**Register Reference: SD22A/0356 AI**

**Development:** Development on a site located south of Oldcourt Road, which forms part of all overall permitted residential development granted under Ref. SD17A/0468 & has the approved name of Ballycullen Gate; The proposed development consists of changes of dwelling type and increase in unit number from 17 permitted houses to 24 proposed houses; The proposed dwellings are comprised of the following: 5 three bed detached bungalows; 1 two bed detached bungalow; 2 two bed semi-detached bungalows; 1 two storey, 4 bed, detached house; 1 two storey, 3 bed, detached house; 2 two storey, 2 bed, semi-detached houses & 12 two storey, 3 bed, semi-detached houses; The proposed development also includes for all associated site development works, car parking, open spaces, and landscaping, on a site area of c. 0.88 ha. The proposed development will have the effect of modifying extant permission Ref. SD17A/0468 which has an overall site area of 3.8 hectares.

**Location:** Oldcourt Road, Firhouse, Dublin 24.

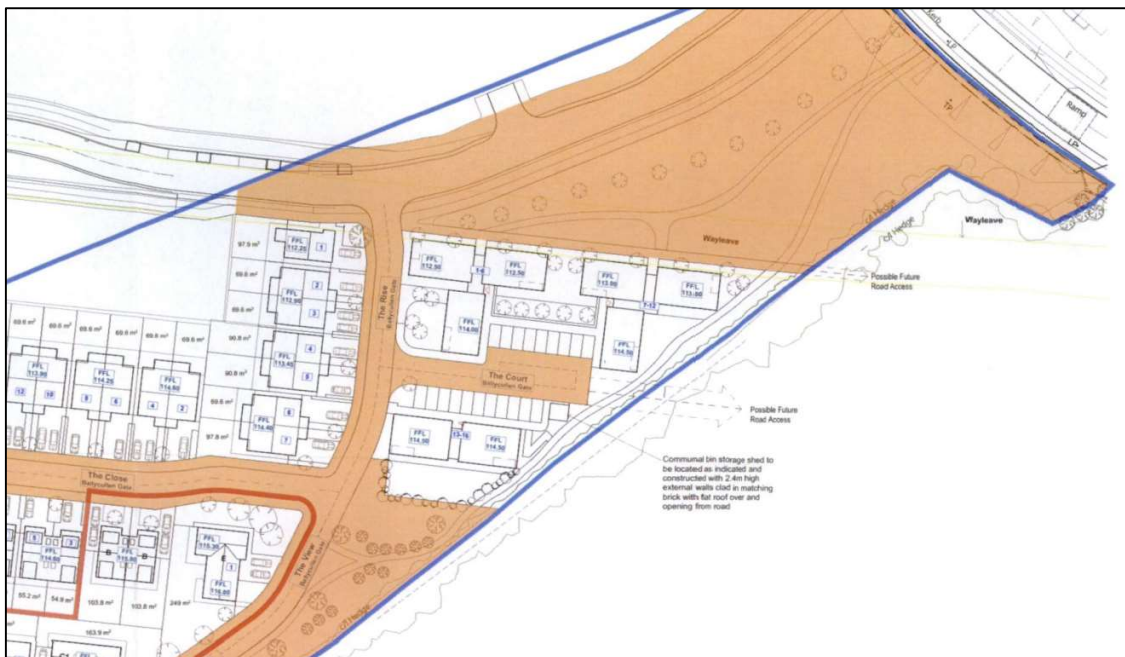
The applicant has considered designing a cycle link with a number of bends however this generally deemed redundant by the National Cycle Manual.

It is therefore suggested that accessibility for cyclists will be as per the existing extant permission as the solution required to answer Item 2 of the Request for Additional Information, would introduce tight radius bends, multiple ramps and mixing with pedestrians. This type of arrangement will not be used by cyclists and as such would be a waste of resources.

Accessibility and permeability for cyclists and pedestrians is illustrated in Pinnacle Engineering Drawing No. P190302 -PIN-XX-DR-D-020-S1 via the central access point. This drawing clearly illustrates key desire lines i.e. towards Old Court Road are fully catered for which negates the need for a formal two way cycle and pedestrian connection that connects with the Link Street. Instead, the application will rely on the principals agreed upon through the extant permission.

These principles are based on the recommendation of DMURs and the National Cycle Manual which allows for cyclists to be on road as illustrated in the figure below, for standard urban speeds and traffic volumes similar to local streets and collector roads.

SDCC Roads Department is satisfied with the applicant's revised response. The instalment of a cycle path with multiple hairpin bends would render it impractical for cyclists.

The applicant should maintain a pedestrian connection at this point in order to maintain some level of permeability.
